**Northeast  
Nuclear Energy**

MAR 19 1999  
Docket No. 50-423  
B17343

**Millstone Nuclear Power Station, Unit No. 3  
Proposed Revision to Technical Specification  
Spent Fuel Pool Rerack (TSCR 3-22-98)**

**FIGURE 3.9-1 Minimum Fuel Assembly Burnup Versus Nominal Initial Enrichment for Region 1 4-OUT-OF-4 Fuel Storage Configuration**

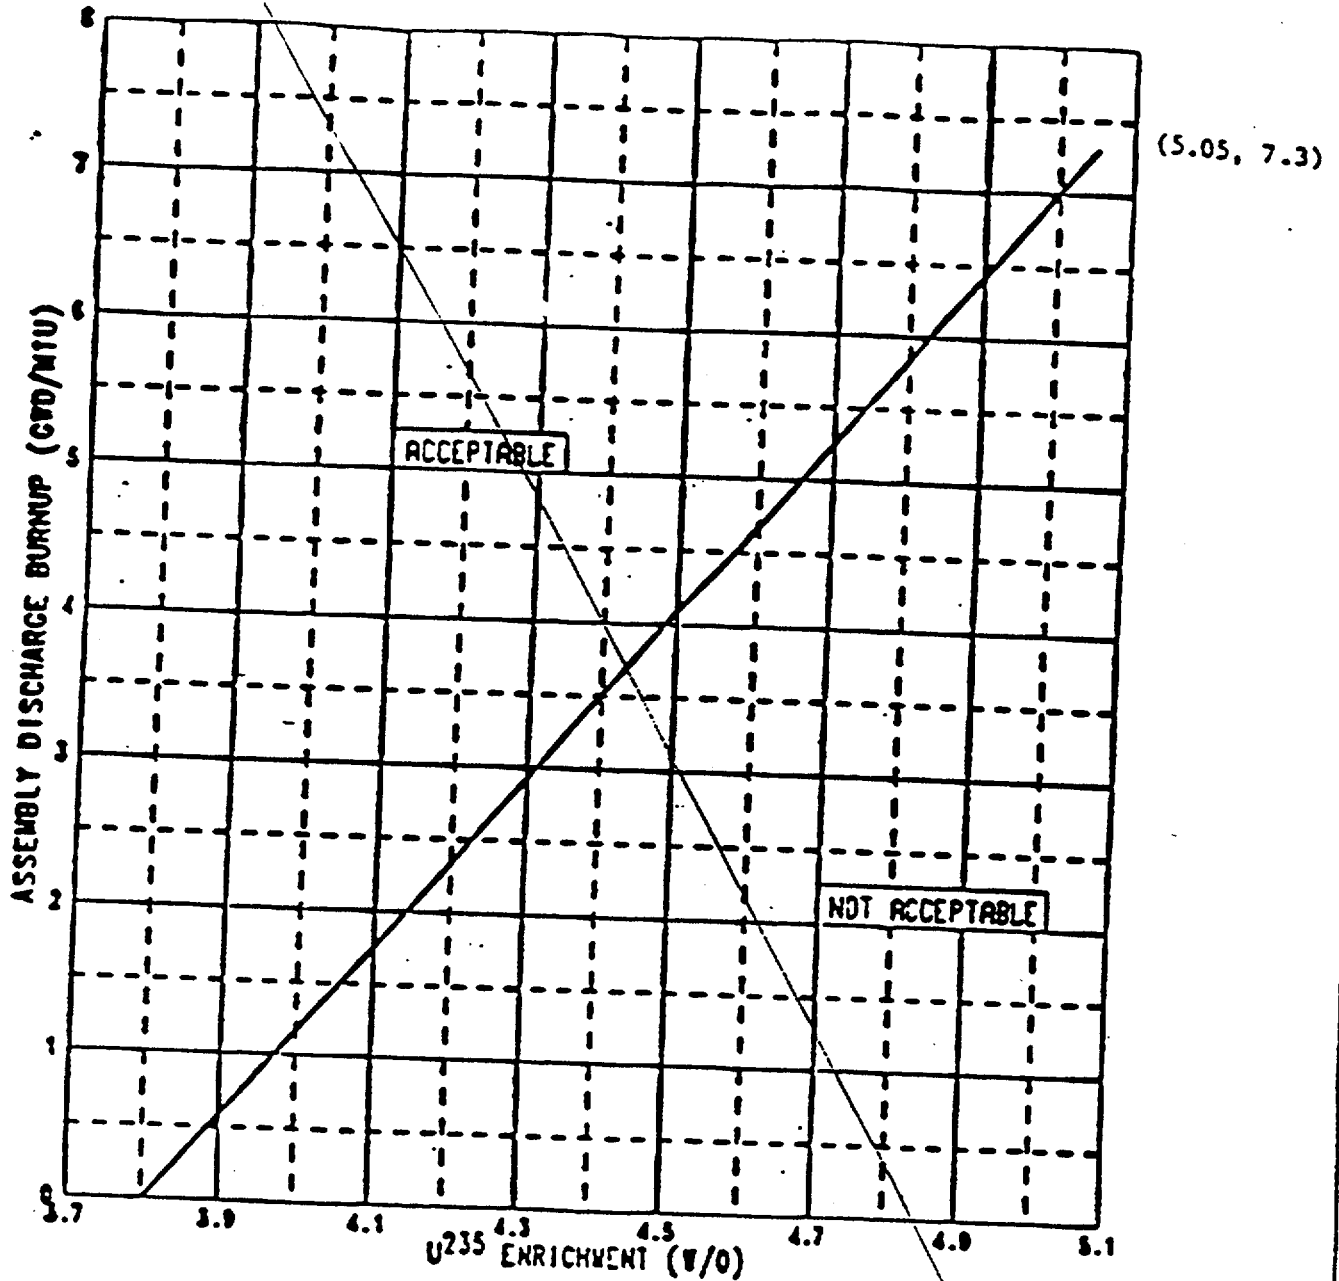
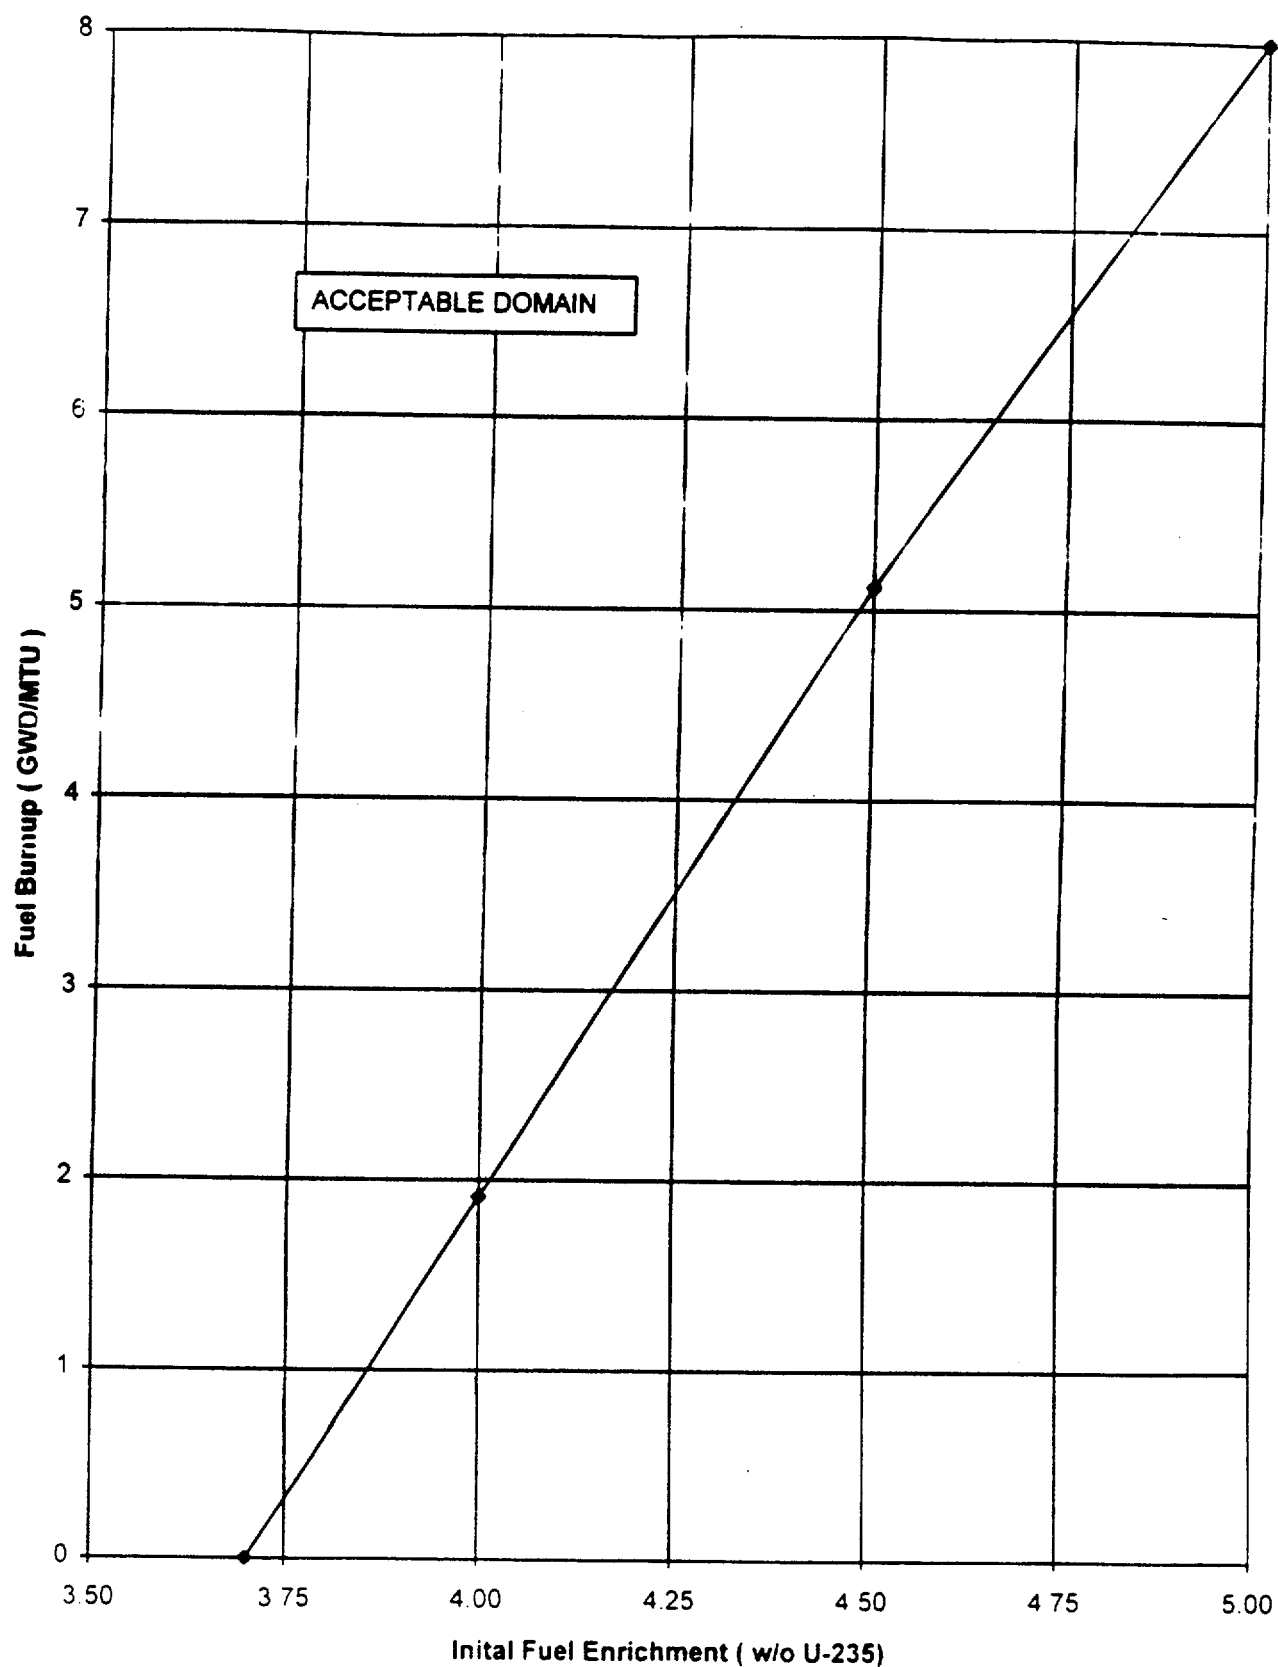
racks meet the burnup/enrichment requirements of Figure 3.9-1 (replaces old figure). Add Section 4.9.13.1.2 which requires appropriate documentation be reviewed to assure that fuel assemblies stored in Region 2 fuel racks meet the burnup/enrichment requirements of Figure 3.9-3 (new figure). Add Section 4.9.13.1.3 which requires appropriate documentation be reviewed to assure that fuel assemblies stored in Region 3 fuel racks meet the burnup/enrichment/decay time requirements of Figure 3.9-4 (new figure). Delete Sections 3.9.13c and 3.9.13d: SPENT FUEL POOL - REACTIVITY and associated Sections 4.9.13.2 and 4.9.13.3: SURVEILLANCE REQUIREMENTS. These sections deal with Boraflex integrity in response to a dropped load on a fuel rack, and in response to an Operating Basis Earthquake (OBE). The proposed reracking project eliminates all credit for Boraflex, and places burnup/enrichment/decay time requirements on fuel assemblies stored in Boraflex racks to assure  $k_{eff}$  remains less than or equal to 0.95.

Replace Figures 3.9-1 and 3.9-2 with new figures 3.9-1, 3.9-2, 3.9-3 and 3.9-4 indicating storage requirements for the proposed Regions 1, 2 and 3 fuel racks.

- 4.9.13.1a.1 Ensure that all fuel assemblies to be placed in Region 1 "4-OUT-OF-4" fuel storage are within the enrichment and burnup limits of Figure 3.9-1 by checking the fuel assembly's design and burn-up documentation.
- 4.9.13.1b.2 Ensure that all fuel assemblies to be placed in Region 2 fuel storage are within the enrichment and burnup limits of Figure 3.9-3 by checking the fuel assembly's design and burn-up documentation.
- 4.9.13.1c.3 Ensure that all fuel assemblies to be placed in Region 3 fuel storage are within the enrichment, decay time, and burnup limits of Figure 3.9-4 by checking the fuel assembly's design, decay time, and burn-up documentation.

Maintaining  $K_{eff}$  at less than or equal to 0.95 is accomplished in Region 1 4-OUT-OF-4 storage racks by the combination of geometry of the rack spacing, the use of fixed neutron absorbers in the racks, and the limits on fuel enrichment/fuel burnup specified in Figure 3.9-1.

REGION 1 3-OUT-OF-4 STORAGE FUEL ASSEMBLY LOADING SCHEMATIC

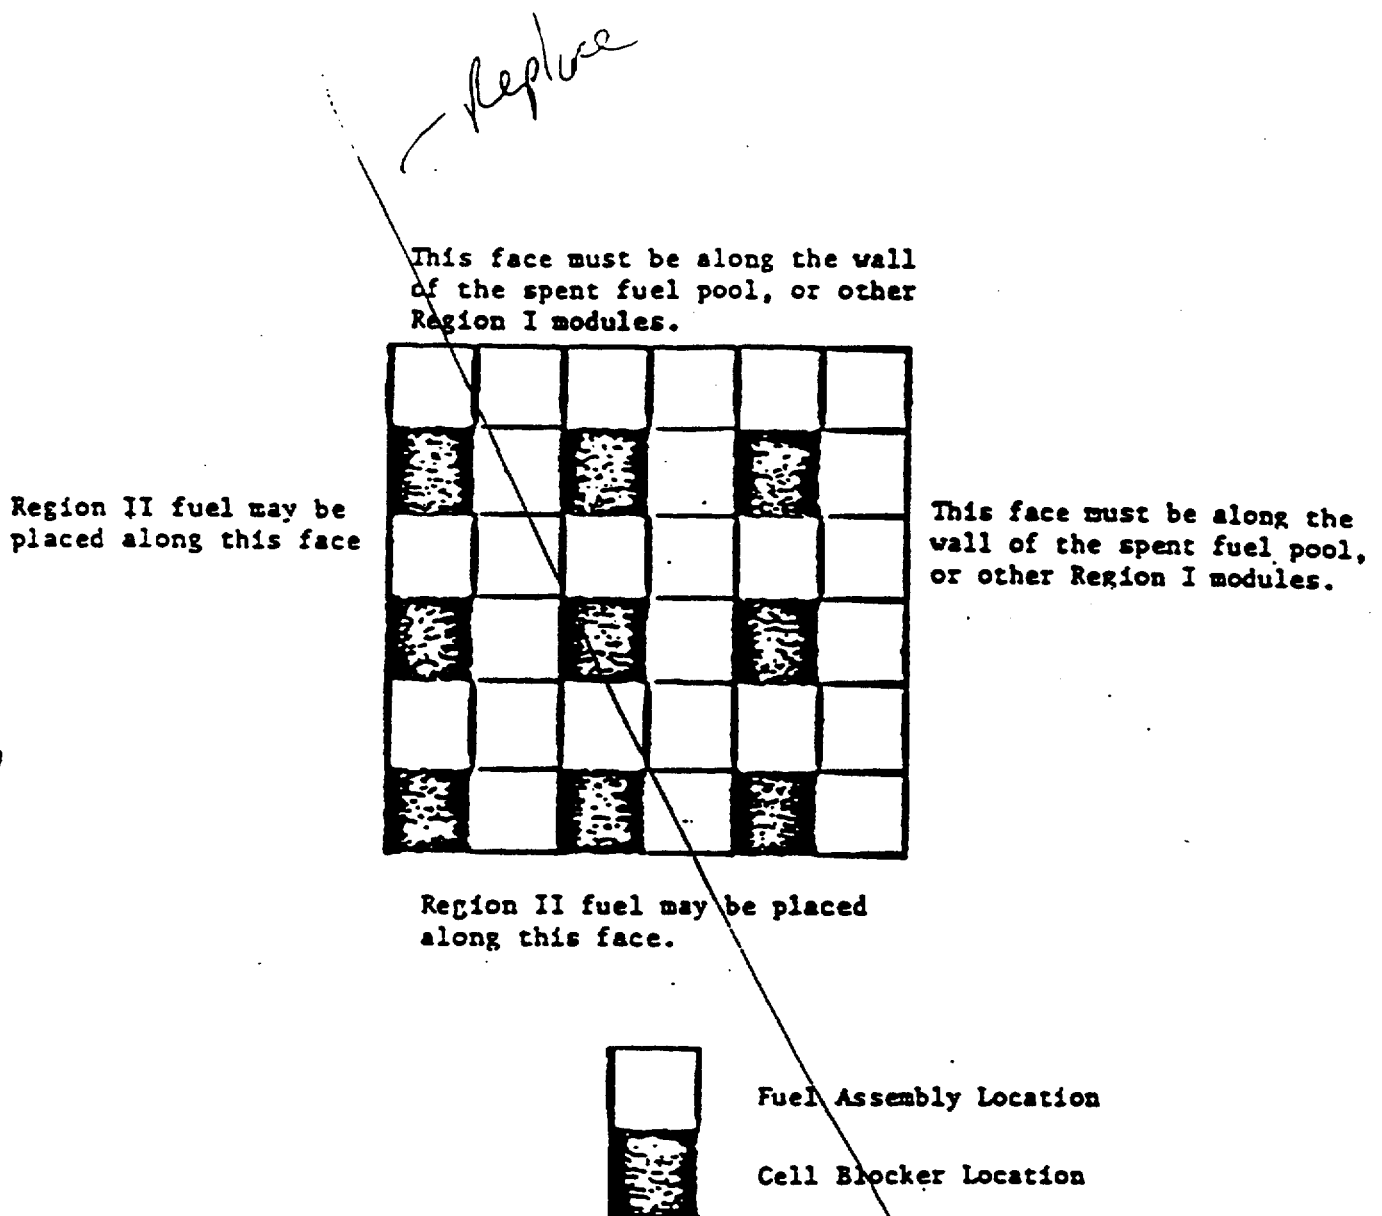
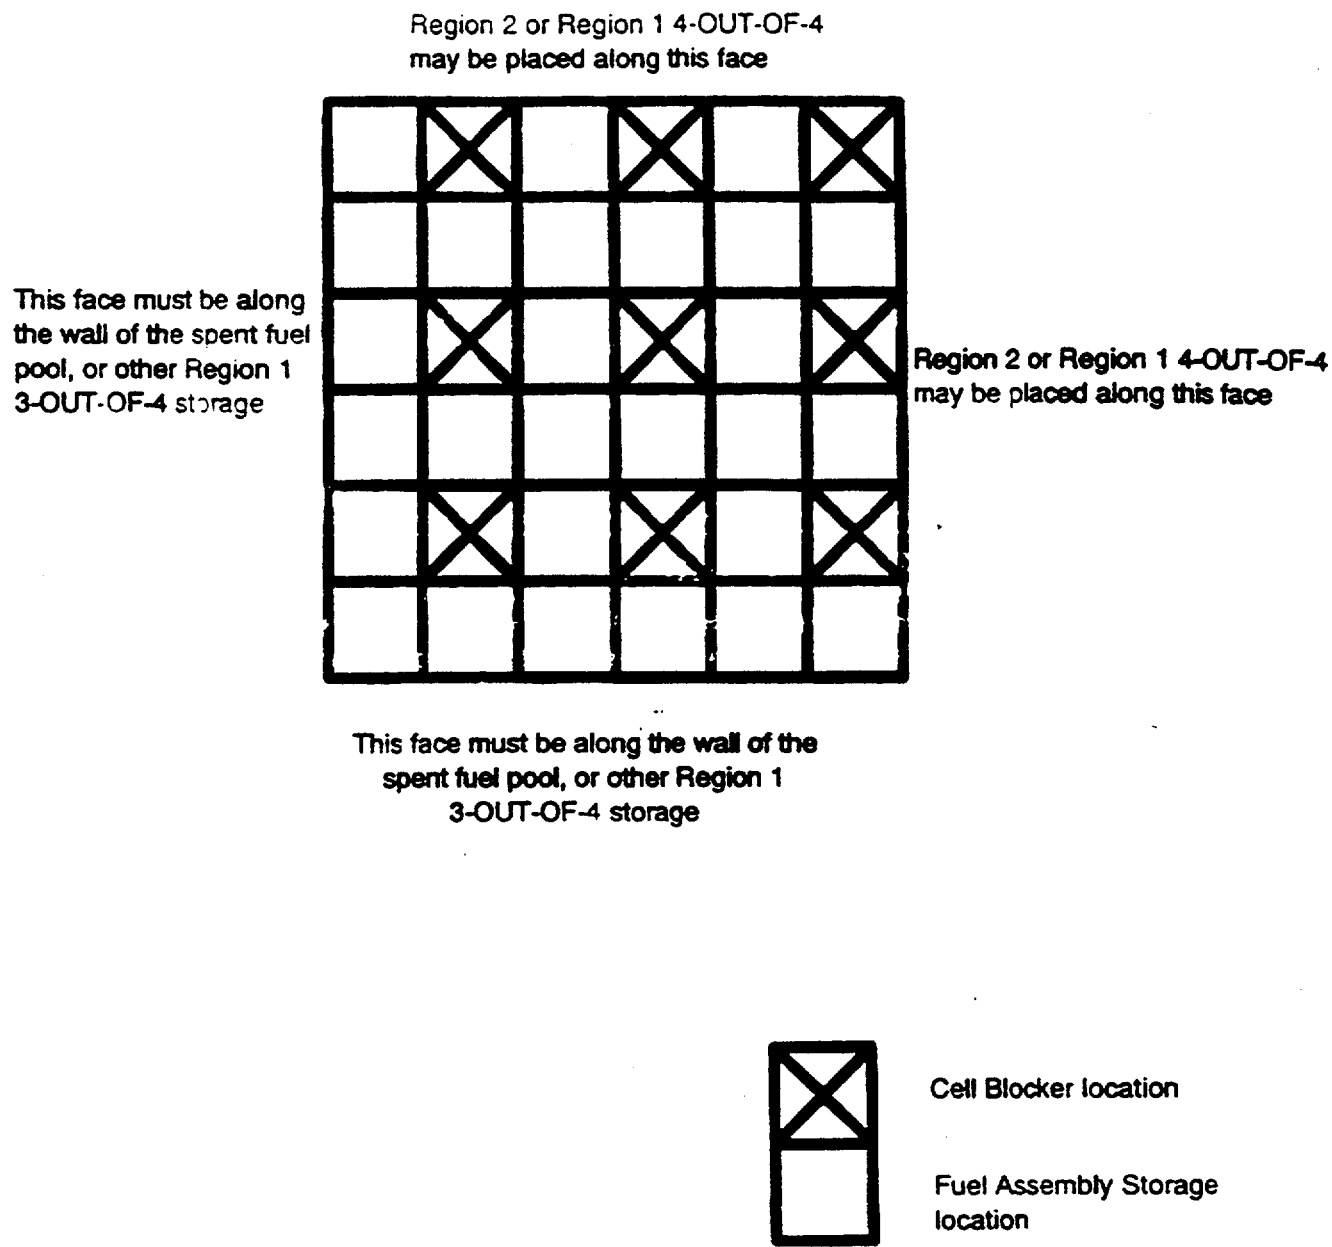
- a. Prior to storing fuel assemblies in the STORAGE PATTERN per Figure 3.9-2, the cell blocking device for the cell location must be installed.
- b. Prior to removal of a cell blocking device from the cell location per Figure 3.9-2, the STORAGE PATTERN must be vacant of all stored fuel assemblies.

Maintaining  $K_{eff}$  at less than or equal to 0.95 is accomplished in Region 1 3-OUT-OF-4 storage racks by the combination of geometry of the rack spacing, the use of fixed neutron absorbers in the racks, a maximum nominal 5 weight percent fuel enrichment, and the use of blocking devices in certain fuel storage locations, as specified by the interface requirements shown in Figure 3.9-2.

FIGURE 3.9-4 Minimum Fuel Assembly Burnup and Decay Time Versus Nominal Initial Enrichment for Region 3 Storage Configuration

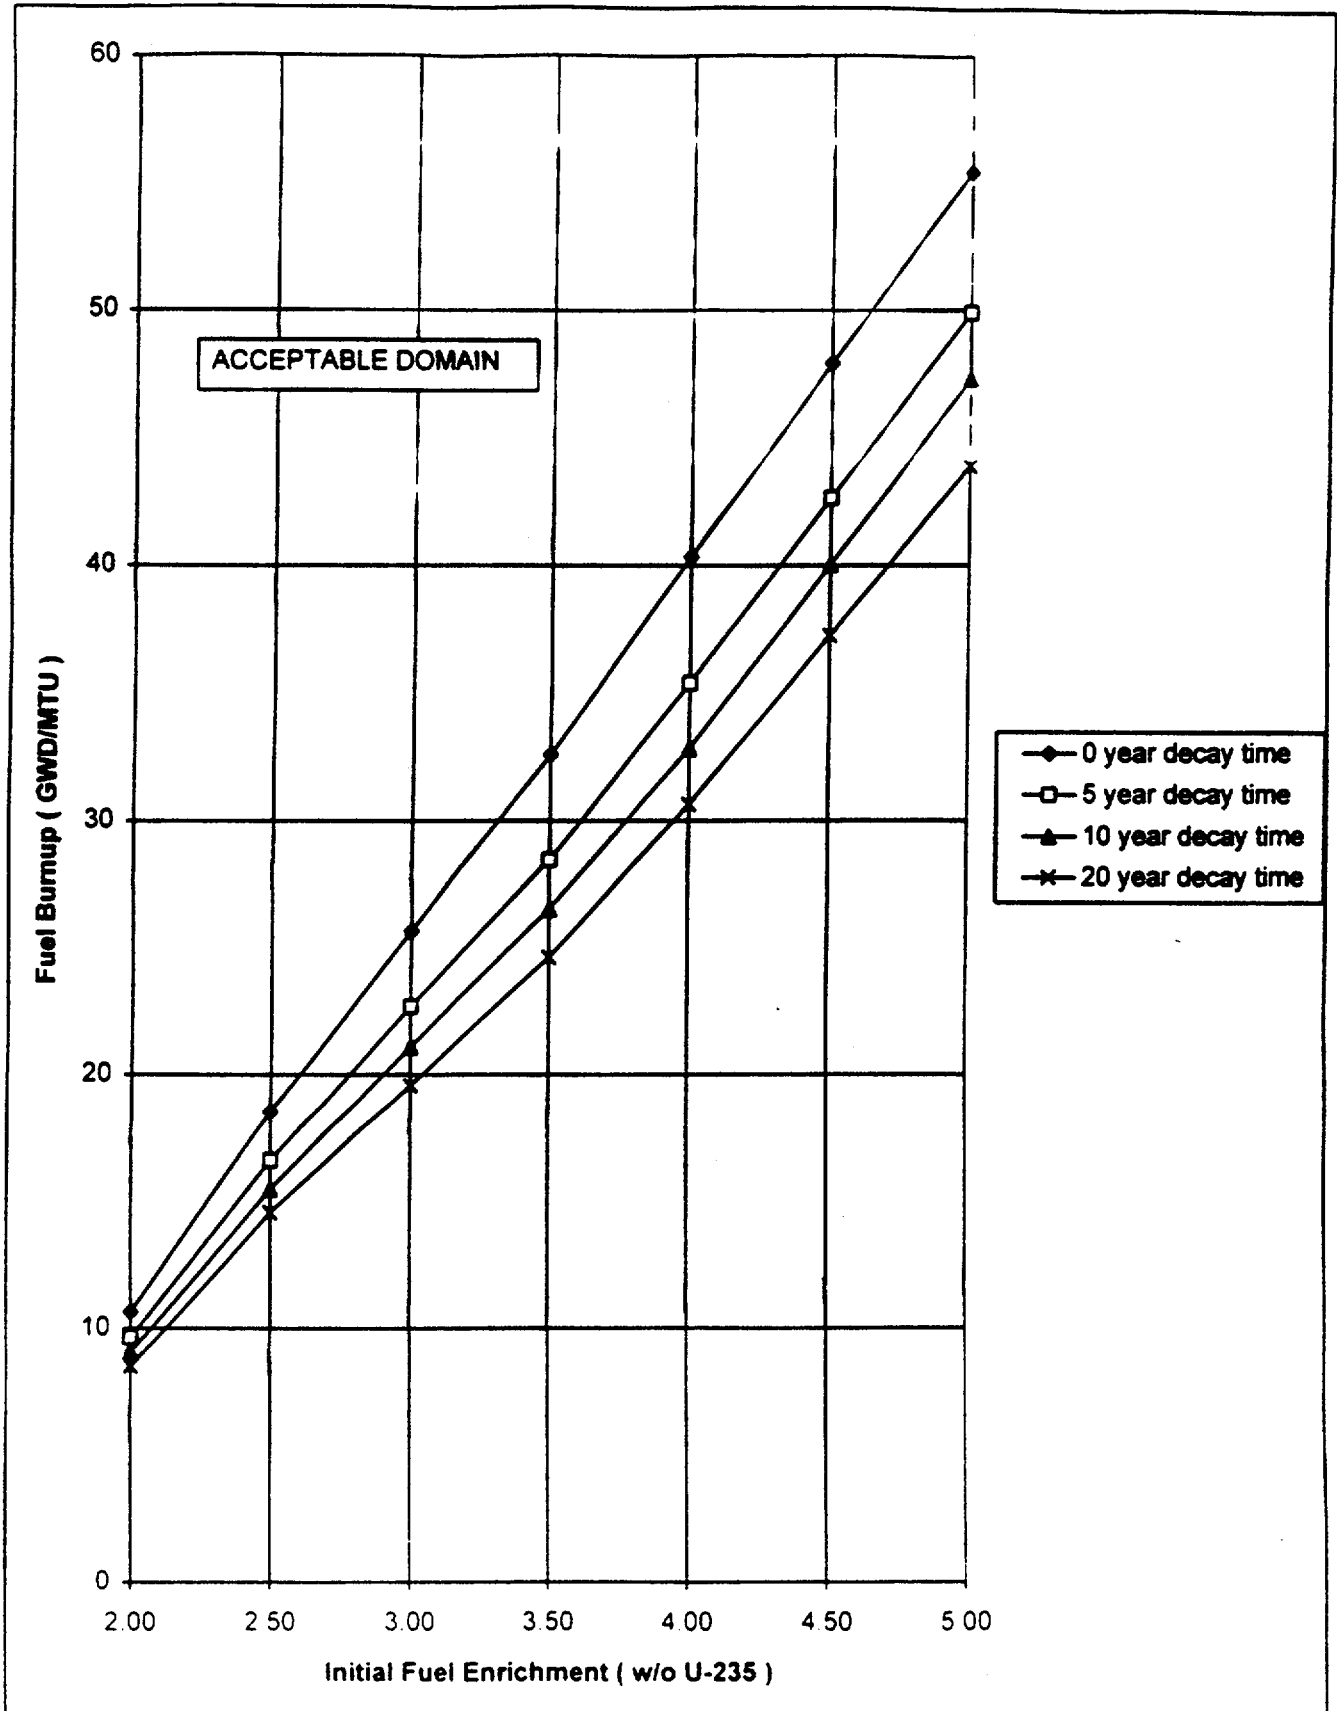
assembly is qualified, renumber Section 4.9.13.1 to 4.9.13.1.1 which requires appropriate documentation be reviewed to assure that fuel assemblies stored in a 4-out-of-4 storage pattern in Region 1 fuel racks meet the burnup/enrichment requirements of Figure 3.9-1 (replaces old figure), add Section 4.9.13.1.2 which requires appropriate documentation be reviewed to assure that fuel assemblies stored in Region 2 fuel racks meet the burnup/enrichment requirements of Figure 3.9-3 (new figure) and add Section 4.9.13.1.3 which requires appropriate documentation be reviewed to assure that fuel assemblies stored in Region 3 fuel racks meet the burnup/enrichment/decay time requirements of Figure 3.9-4 (new figure).

Maintaining  $K_{eff}$  at less than or equal to 0.95 is accomplished in Region 3 storage racks by the combination of geometry of the rack spacing and the limits on fuel enrichment/fuel burnup and fuel decay time specified in Figure 3.9-4. Fixed neutron absorbers are not located in the Region 3 fuel storage racks.
